# RENESAS TECHNICAL UPDATE

Product Category	MPU/MCU		Document No.	TN-RX*-A084A/E	Rev.	1.00
Title	Usage Notes on 12-Bit A/D Converter		Information Category	Technical Notification		
Applicable Product	RX62T Group RX62G Group RX63T Group	Lot No.	Reference Document	RX62T Group User's Manual: Hardware Rev. 1.30 (R01UH0034EJ0130) RX62G Group User's Manual: Hardware Rev. 1.00 (R01UH0321EJ0100) RX63T Group User's Manual: Hardware Rev. 2.10 (R01UH0238EJ0210)		
		All lots

Figure 1 Normal and Erroneous Double Data Register Operations 1

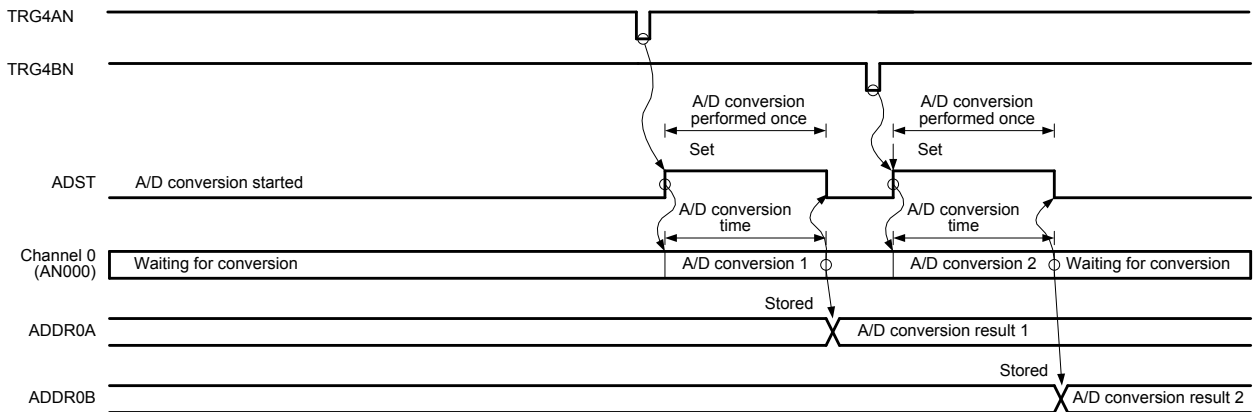
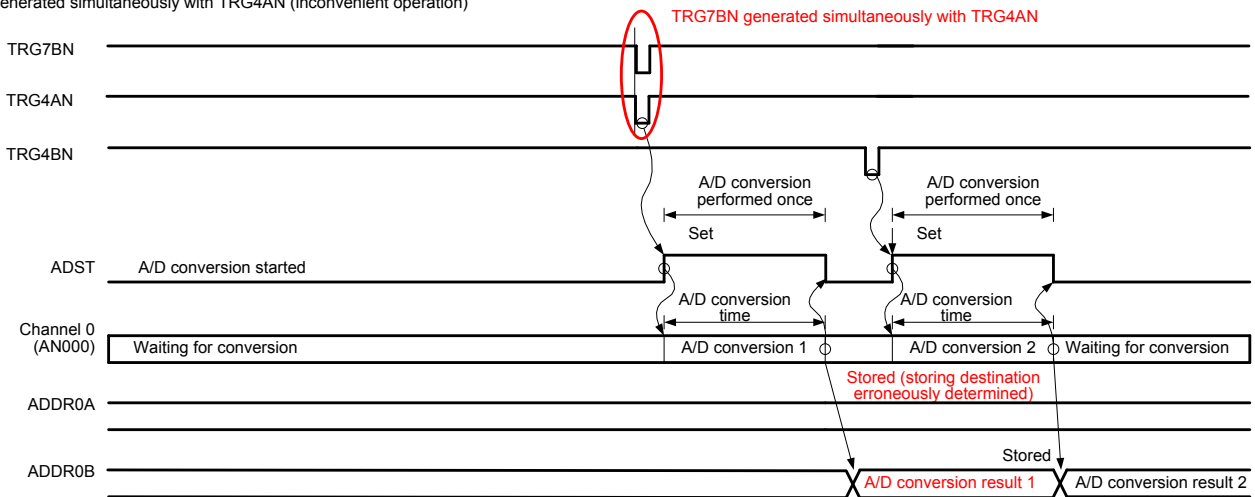
(1) Data to be stored in ADDR0A is erroneously stored in ADDR0B if any of TRG4BN/TRG7BN/GTADTRBn (n = 0 to 3), regardless of whether or not it is selected as an A/D conversion start trigger, is generated simultaneously with any of TRG4AN/TRG7AN/GTADTRAn (n = 0 to 3) that is selected as an A/D conversion start trigger. Figure 1 shows the comparison of the normal and erroneous operation timing.

TRG7BN generated simultaneously with TRG4AN (inconvenient operation)

A/D conversion result of TRG4AN should be stored in ADDR0A, but is erroneously stored in ADDR0B.  
 A/D conversion result of TRG4BN is stored in ADDR0B.

- (1) Do not use the double data register function of the RX62T or RX62G Group product, or extended double trigger mode of the RX63T Group [144-, 120-, 112- and 100-pin versions] product.
- (2) When the double data register function of the RX62T or RX62G Group product is selected, do not allow generation of any of TRG4BN/TRG7BN/GTADTRBnN (n = 0 to 3) unless it is selected as an A/D conversion start trigger.
- (3) When extended double trigger mode of the RX63T Group [144-, 120-, 112- and 100-pin versions] product is selected, do not allow generation of any of TRG4BN/TRG7BN/GTADTRBnN (n = 0 to 7) unless it is selected as an A/D conversion start trigger.
- (4) When extended double trigger mode of the RX63T group [64- and 48-pin versions] product is selected, you can avoid the problem that you do not want to generate a trigger other than to be used as A / D conversion start trigger.

Figure 2 Normal and Erroneous Double Data Register Operations 2

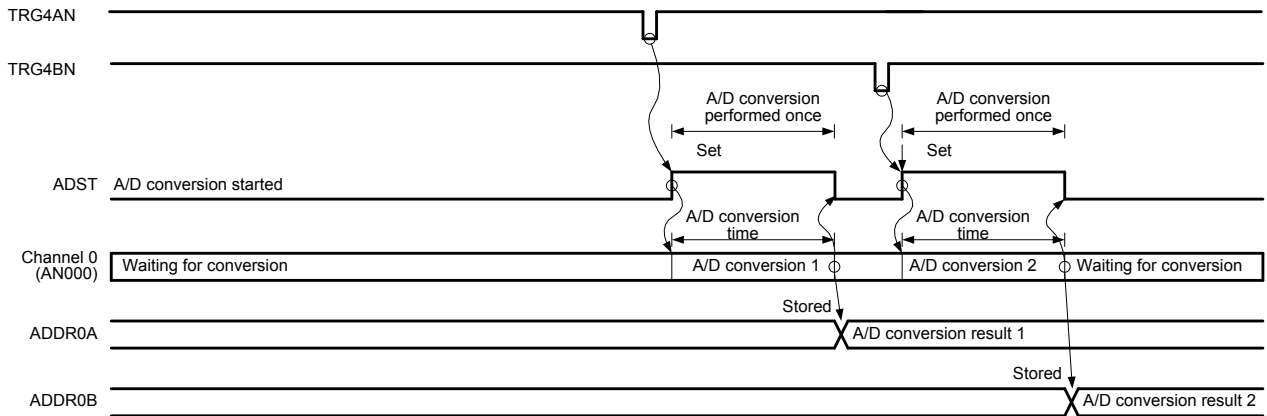
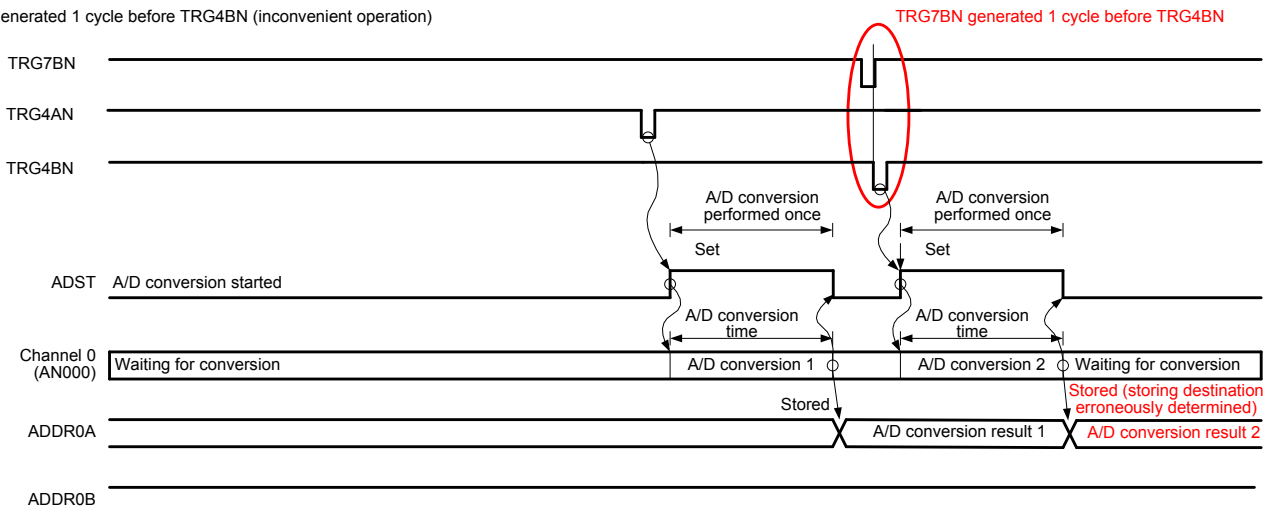
(2) Data to be stored in ADDR0B is erroneously stored in ADDR0A if any of TRG4BN/TRG7BN/GTADTRBnN (n = 0 to 3) that is not selected as an A/D conversion start trigger is generated 1 cycle before any of TRG4BN/TRG7BN/GTADTRBnN (n = 0 to 3) that is selected as an A/D conversion start trigger. Figure 2 shows the comparison of the normal and erroneous operation timing.

TRG7BN generated 1 cycle before TRG4BN (inconvenient operation)

A/D conversion result of TRG4AN is stored in ADDR0A.  
 A/D conversion result of TRG4BN should be stored in ADDR0B, but is erroneously stored in ADDR0A.
